**Peninsula Housing Authority**  
**Addendum #1**  
**Questions & Answers**

### 3 RECEPTION DESK - EAST

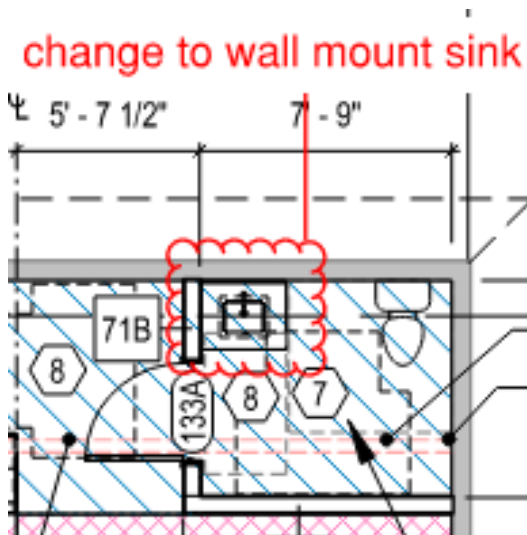
1. Not real familiar with the section 3 form – are we required to advertise and hire people for the project or is it ok to do with our own forces? **You are not required to hire other personnel for this project. If you do though, then compliance with Section 3 is needed. See bullet 1 on the first page.**
2. Reading through the gen conditions it talks about contractor reimbursing for utilities used during construction – is this something we need to account for? **Since the building is currently connected to all utilities, this is not needed. The PHA will pay the utilities.**
3. Shows reception window and calls for a wood desk top – couldn't find any details on a wood desk top or how the glass is framed in or detailed **See revised plans below...**

revise head to 7'-0" AFF;  
increase window size.  
spec glazing thickness for  
security.

provide laminate  
counter/detail. check  
ADA counter height.

## KITCHENETTE - EAST

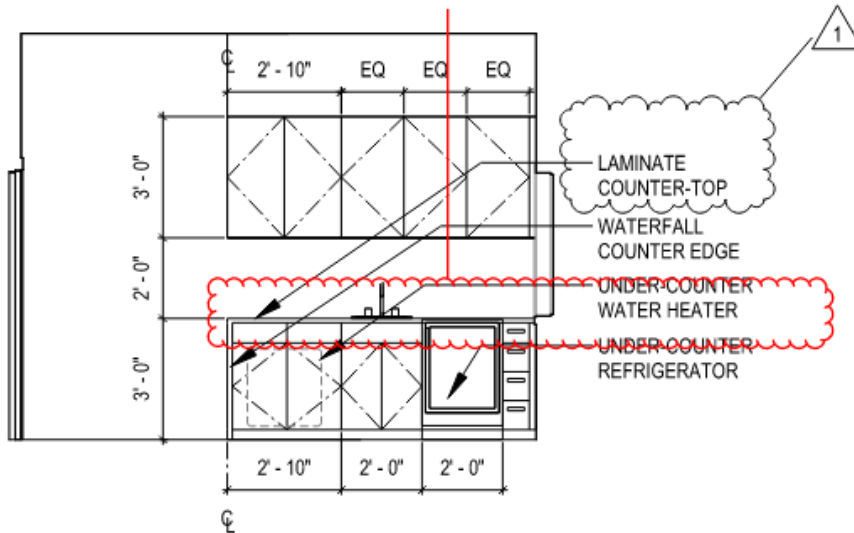
4. New cabinets – assuming mods in kitchen are to match similar to existing? What about the new kitchenette and bathroom top? **Match existing materials – bathroom shall have wall mount sink. See below.**

laminite countertops. at new and existing kitchen to match existing type. Owner to select from standard colors.

## KITCHEN - SOUTH

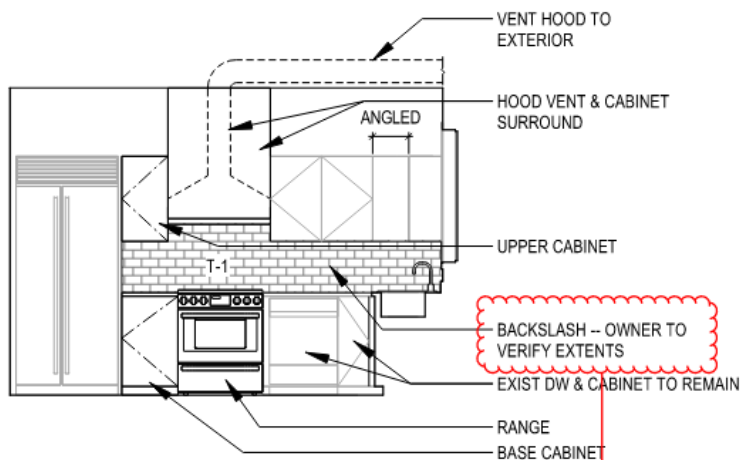
- Is the new kitchen hood to be built in to a new cabinet? Mechanical mentioned some info on the hood but couldn't find a specific product detail **There will be some new cabinets needed to accommodate this change. The hood fan shall be 30", ducted, white, 160cfm (min), max 3 sones, Nutone/Broan or equal.**
- It appears that the existing kitchen is to have a tile backsplash? It also says to verify extent with owner **See revision below**

no full tile. match existing
